**ITEM 4. DEVELOPMENT APPLICATION: 148-160 KING STREET SYDNEY****FILE NO: D/2015/750****DEVELOPMENT APPLICATION NO: D/2015/750****SUMMARY****Date of Submission:** 3 June 2015**Applicant:** Galileo Phillip Street JV Pty. Ltd.**Architect:** Kann Finch & Urban Possible**Developer:** Galileo Phillip Street JV Pty. Ltd.**Owner:** Galileo Phillip Street JV Pty. Ltd.**Cost of Works:** \$71,500,000

**Proposal Summary:** The proposal is a Stage 1 Development Application for a conceptual building envelope to a height datum of RL 120.70 (approximately 92.8m or 27 storeys). The uppermost points of the envelope are defined by the Hyde Park North (2A) sun access plane. The proposal includes:

Figure 12 Southern (King Street) elevation of proposed envelope.

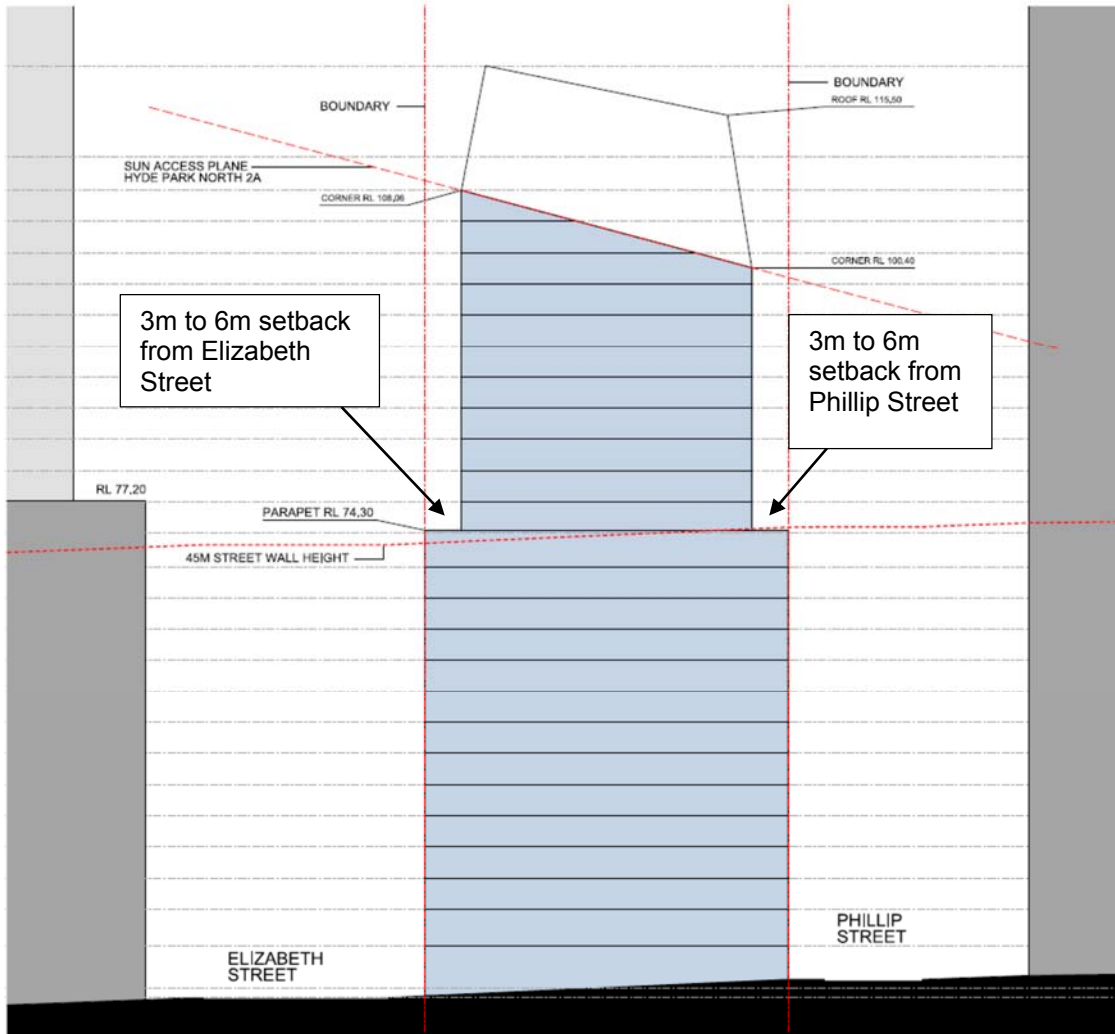
<b>Street</b>	<b>Classification</b>	<b>Requirement</b>	<b>Proposed podium setback</b>
Elizabeth Street	Major north-south street	Weighted average 8m, minimum 6m	3.0m – 6.0m
Phillip Street	North-south street	Weighted average 8m, minimum 6m	3.0m – 6.0m
King Street	Minor street	Minimum 6m	2.4m

45. As detailed in the above table, the proposed envelope does not comply with the DCP requirements. In this instance, the extent of variation is supported as:
- (a) The proposed envelope is considered to be contextually appropriate to the CBD location. The proposed setbacks would enable a future built form that addresses all street frontages and the visually prominent intersection between Elizabeth and King Streets;

- (b) The proposed varied setbacks from the Phillip Street and Elizabeth Street frontages have been developed to maximise solar access to the eastern and western elevations of the tower. Specifically, the angled alignment would extend the length of time which direct solar access would reach the eastern and western elevations. This would increase the proportion of floor space / apartments that has the opportunity to receive direct solar access when compared to a DCP compliant scheme. The proposed envelope would contribute to the amenity and energy efficiency of the future building;
- (c) The reduced setbacks will not result in an unacceptable building mass as viewed from the public domain (refer to Figures 14 and 15 below). The bulk and scale of the building would be further addressed through articulation of the building envelope at the detailed design stage;

**Figure 14** Building envelope with 8m setback from Elizabeth Street and 6m setback from Phillip and King Streets, as viewed from Hyde Park.

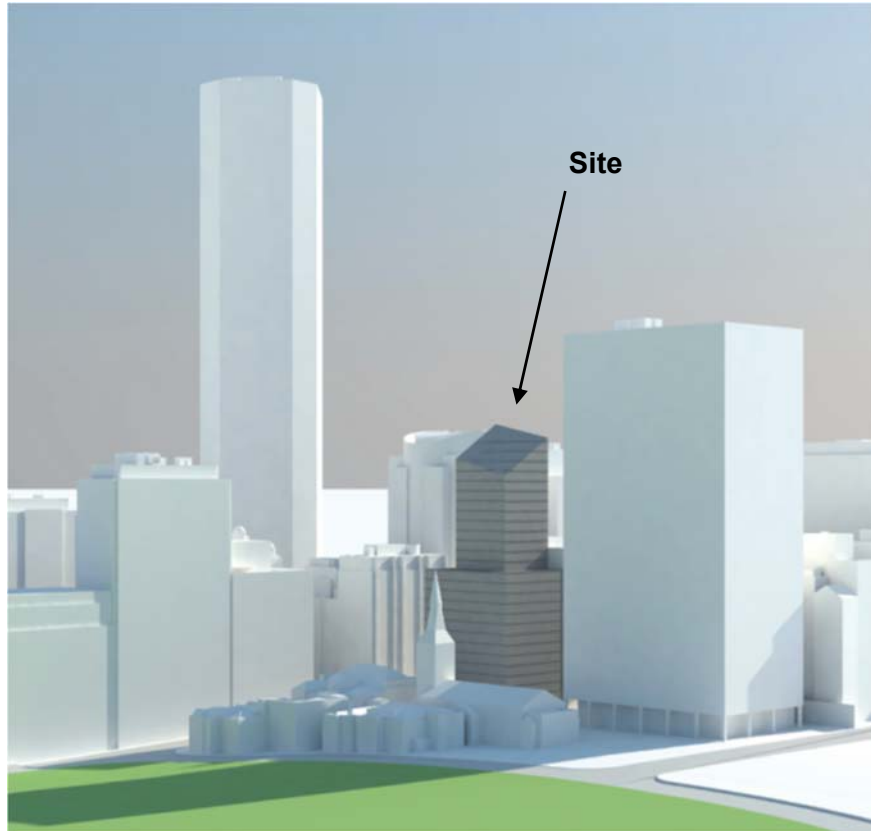
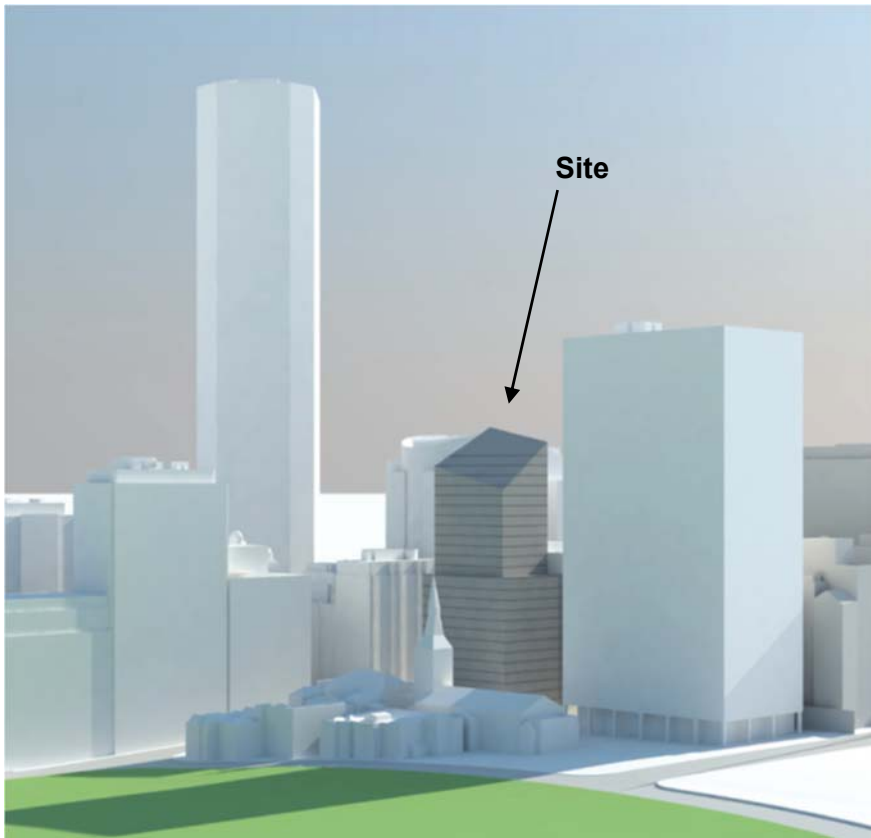
- (d) The tower envelope is separated approximately 31.3m from the office building on the western side of Elizabeth Street and approximately 27.2m from the Commonwealth / State Law Courts building to the east (refer to Figure 18 below). The separation distance exceeds the 24m requirement of the Apartment Design Guide. It should also be noted that the heritage items to the south of the site are low-rise buildings and are unlikely to change in the foreseeable future. Based on the above, it is considered that a reasonable level of daylight and views to the sky would be retained for the surrounding streets;

**Figure 16** Conceptual floor layout with DCP compliant setbacks above podium (approximately 394 sqm floor plate area).

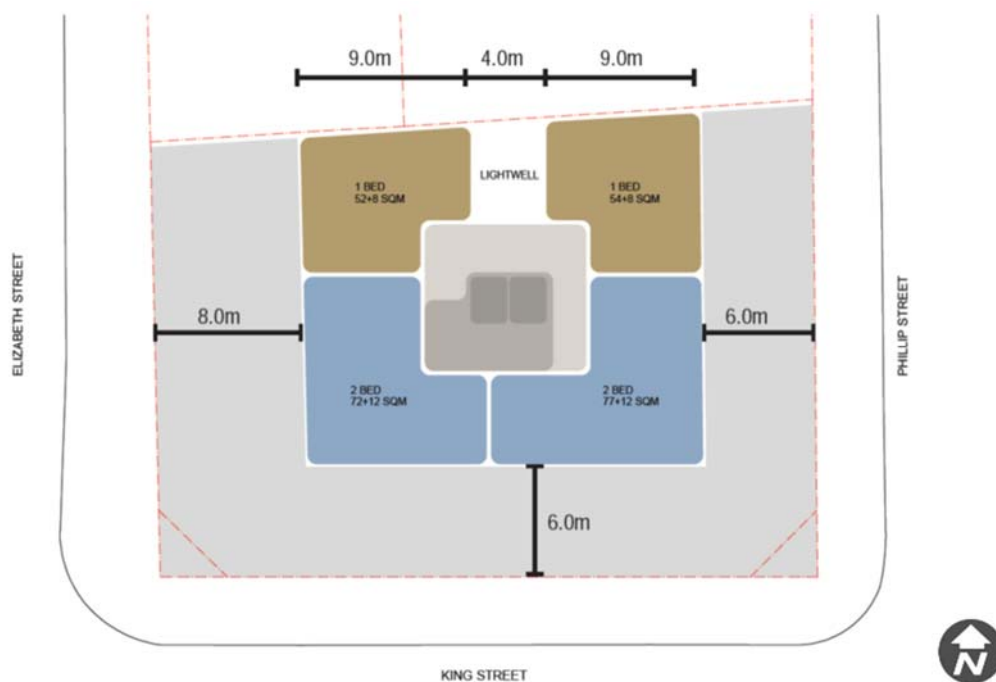
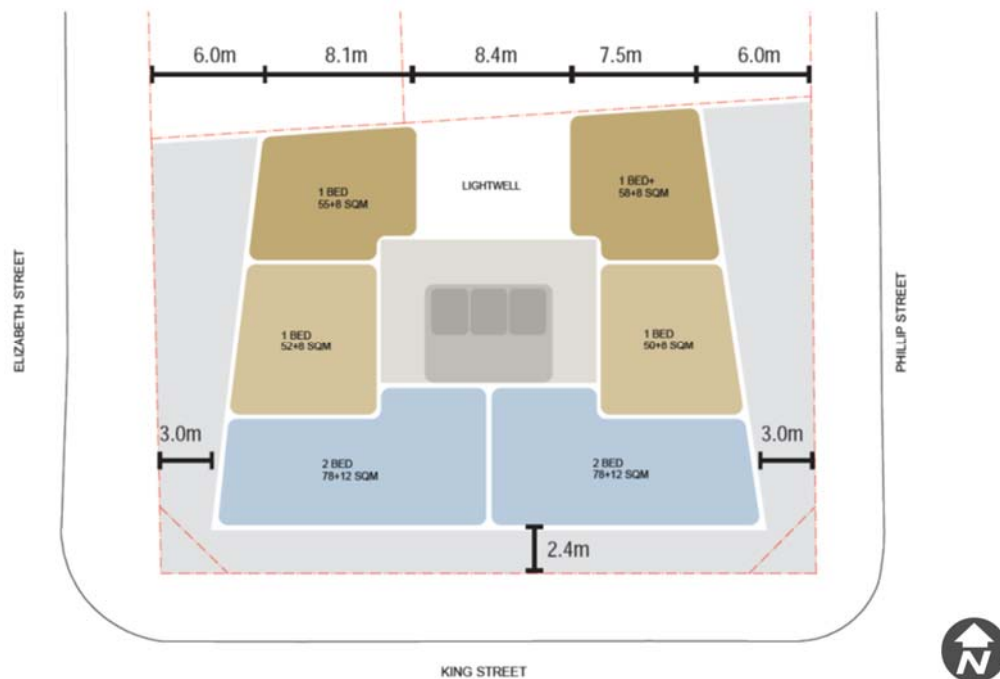
- (f) Strict compliance with the DCP setback requirements would result in highly constrained floor plates that restrict the number and type of potential apartments. A DCP-compliant setback would potentially provide up to 4 apartments per typical storey in the tower (except for levels 23 to 25, which are affected by the sun access plane). Whereas the proposed envelope would provide approximately up to 6 apartments per typical floor within the tower. Refer to Figures 16 and 17 below; and

- (g) The adjoining allotments to the north within the same city block have similar lengths to the subject site. These are in the order of approximately 36m to 39m, as measured from east to west. The 6m setbacks from Phillip and Elizabeth Streets at the northern common boundary would set a benchmark for any future development on the adjoining properties. The proposed setback arrangement is considered to allow any future adjoining developments to achieve a feasible and practical floor plates above the street frontage height.

**Figure 18** Separation distance between proposed envelope and nearby buildings.

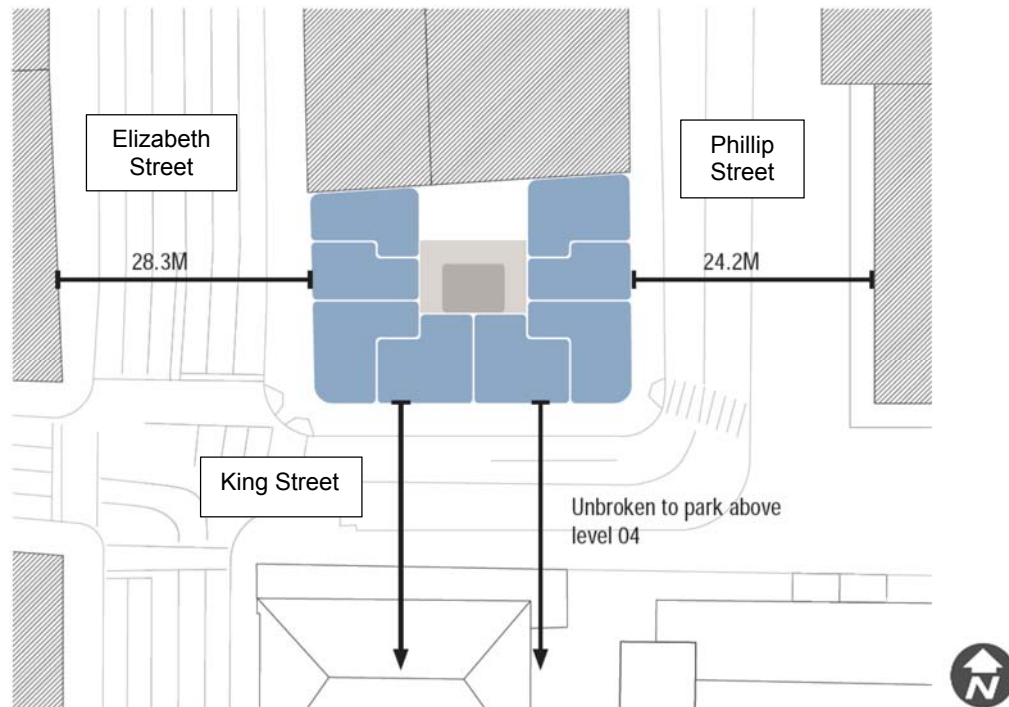
62. The site has three street frontages. **Figure 18**, below, illustrates the separation from the surrounding multi-storey buildings. The podium is approximately 24.2m from the Commonwealth / State Law Courts building to the east, and approximately 28.3m from the office building at No. 75-85 Elizabeth Street to the west. These building separation distances meet the visual privacy requirements of the ADG, being 24m between habitable rooms / balconies.

63. The podium and tower are separated from the street boundary of the Supreme Court and old Registry Office building complex by approximately 19m and 21.4m, respectively. This is a shortfall from the 24m separation requirement of the ADG. Notwithstanding this, the indicative floor plans show that apartments would be located above the first two levels of the building. Due to the heritage listing of the Supreme Court and old Registry Office building group and St. James Church, the likelihood of having multi-storey buildings on these sites are very low, and as such, would not cause any significant privacy impacts on the proposed residential use.
